PN 20-166985
V07 House Start Up Renovation
Type of Original Notice: Request for Bids
Notice Number: 20-166985

ADDENDUM 1

V07 HOUSE START-UP RENOVATION

1 FINISH PLAN - FIRST FLOOR
1/4" = 1'-0"

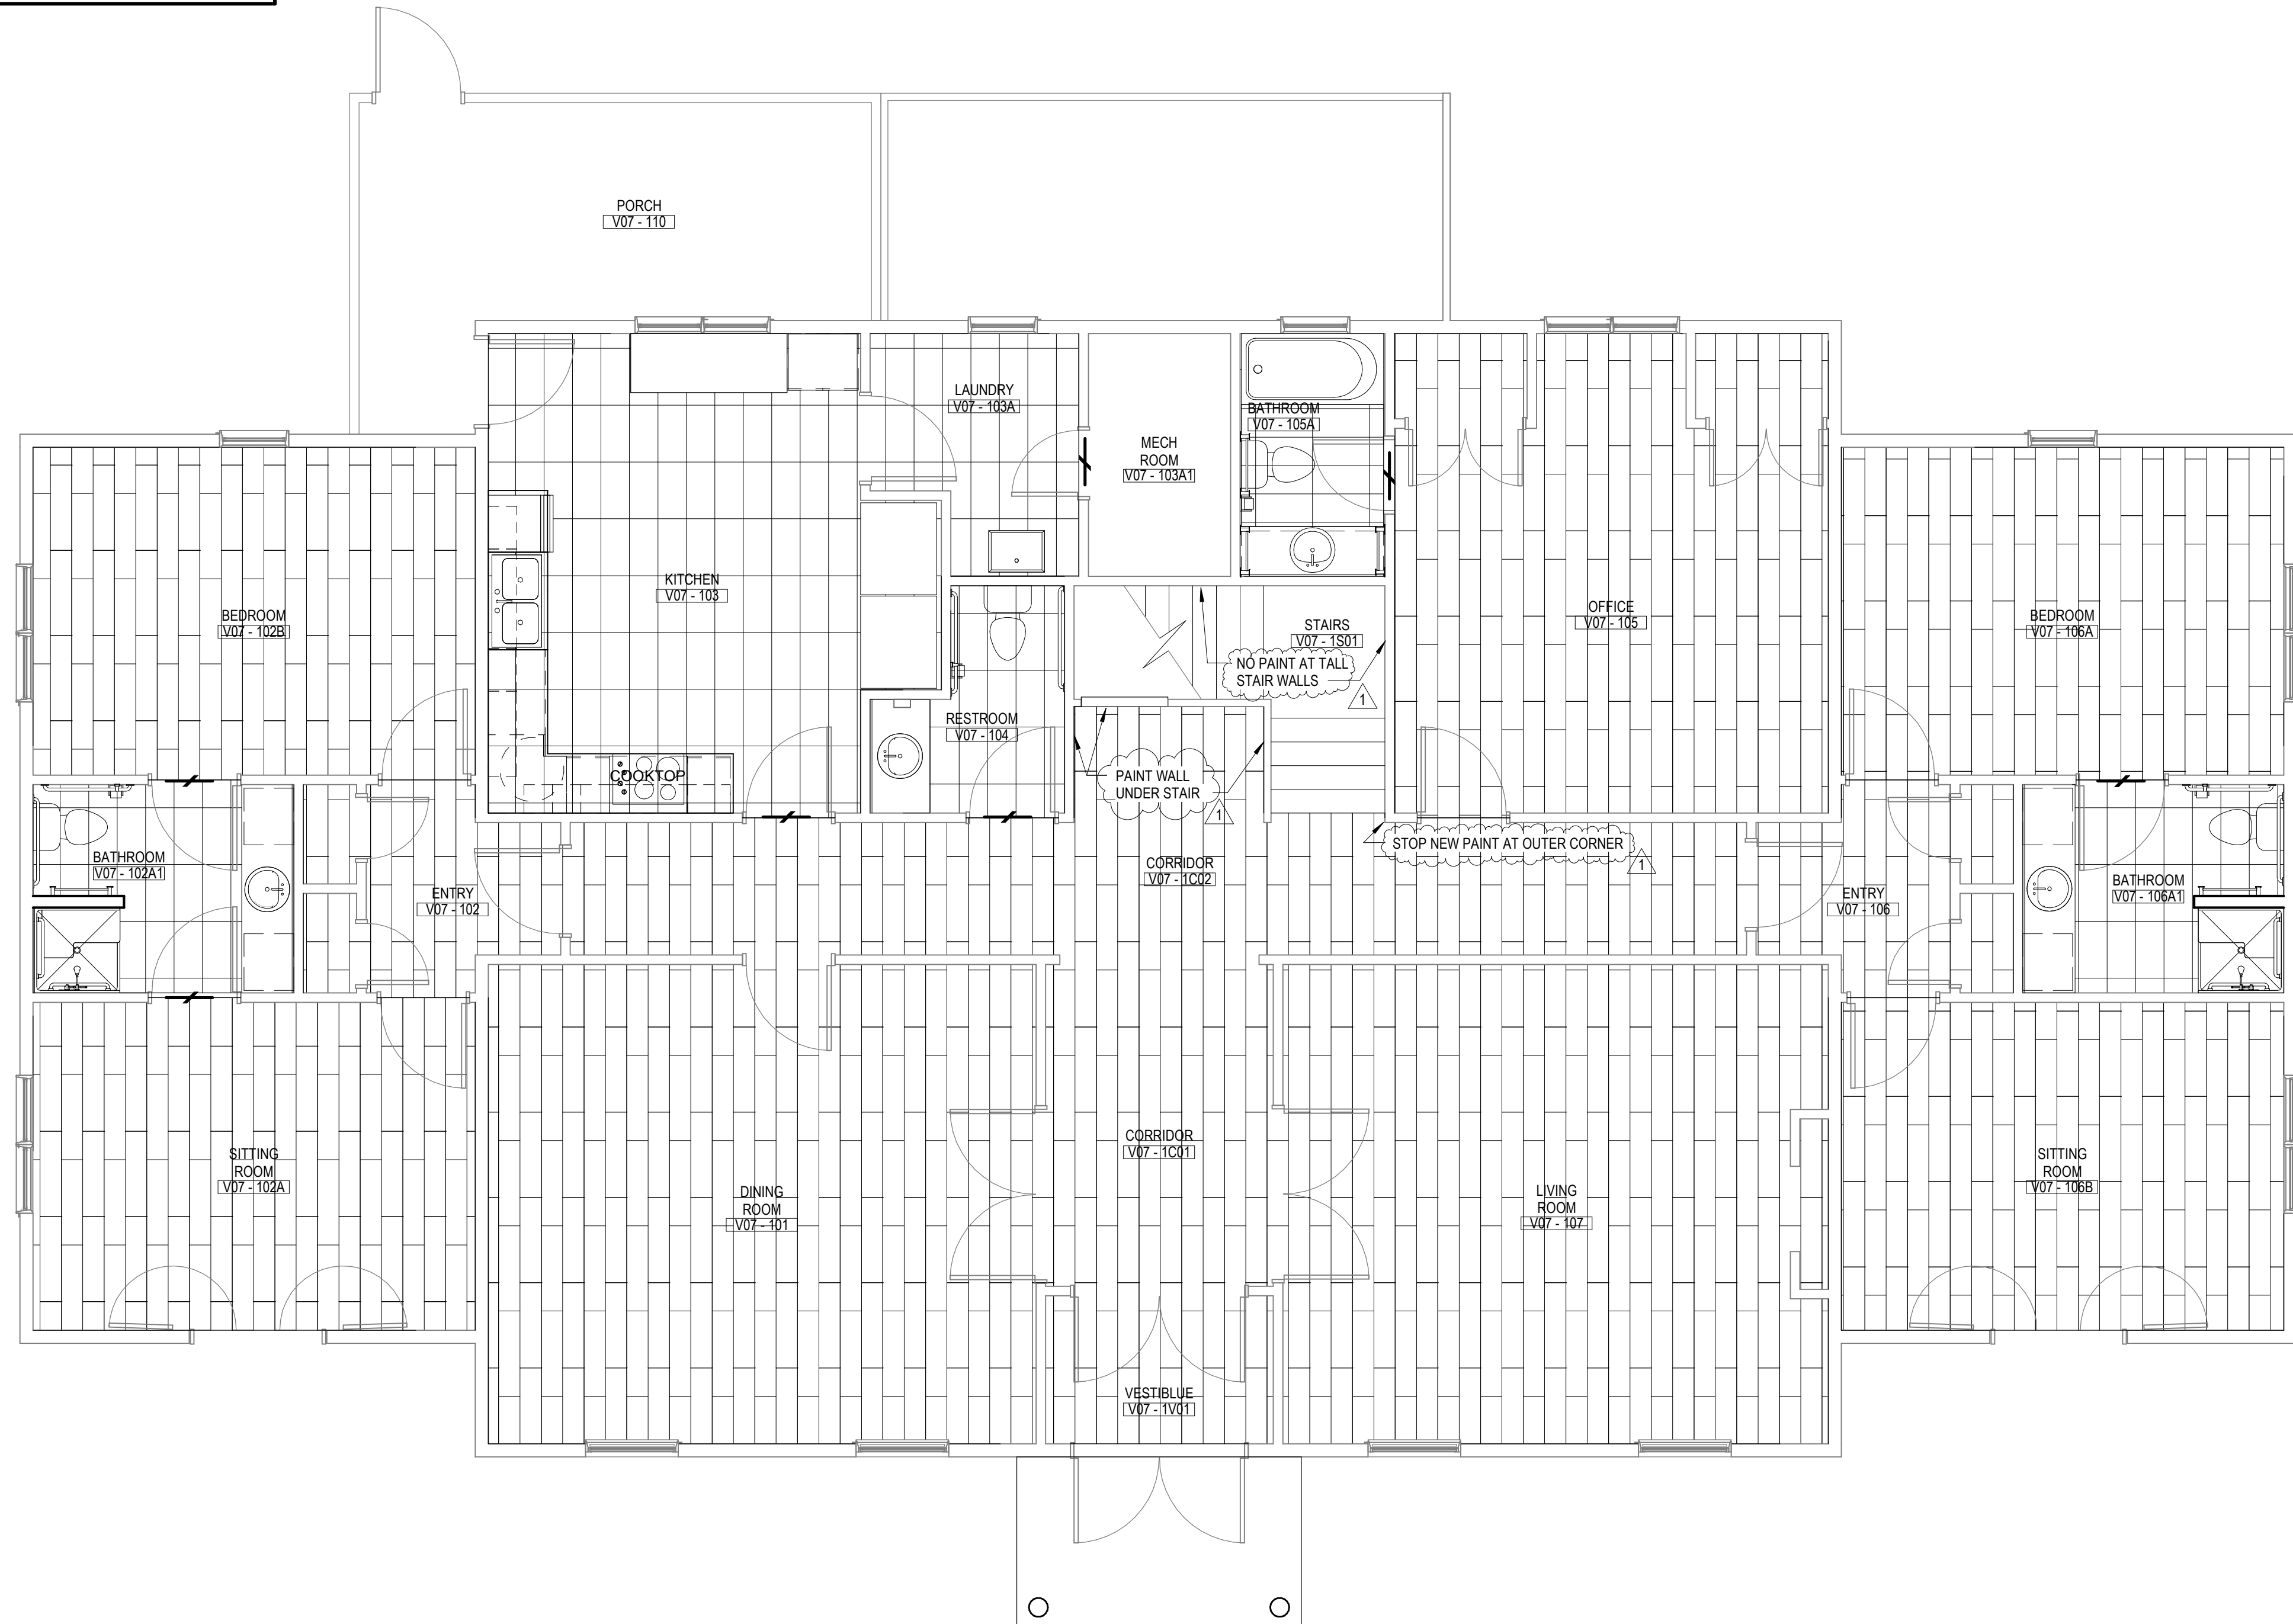
19. A12.01 calls for all trim /casting to be painted. Please confirm this does not include the window shutters. *Response: Painting scope does not include the window shutters, nor doors except the two doors to Bathroom V07-102A1.*

21. A12.01 calls for wood base to match existing. Please confirm the existing wood base is a 2 part base. Painted white base board to match existing profile + solid oak stained quart round. *Response: The existing base is a two-part base. New base is to include a profiled base of the same size, shape and material of the existing base and a quarter round shoe that will now be painted to match the base. No part of the new base will be stained.*

23. Alternate #4 calls for wallpaper removal in specified rooms. A12.01 calls for painting all rooms. Please confirm that the base bid should include any painting of existing gyp board walls, up to any wallpaper, leaving the wallpaper in place. For example, Restroom 104 has top of wall accent wallpaper. For the base bid, we are to paint the entire room, with the exception of the top of wall wallpaper. *Response: The full height walls of Restroom 104 actually have a neutral wallpaper AND a decorative border at the top. Alternate #4 would include removal of all wallpaper and decorative borders in Restroom 104. Base bid shall include painting all walls specified, with the exception of rooms with wallpaper.*

- A12.01** – Added note to Finish Schedule and Finish Plan regarding extent of new wall paint at the open stairway.
- A12.01** - Materials Legend: Added selection for Solid Surfacing countertop material

- A12.01** - Materials Legend: Added note regarding re-use of existing cabinet hardware.
- A13.01** – Elevation C1 – Added clarification note regarding new countertops, sink and faucet and added (2) 18” towel bars.
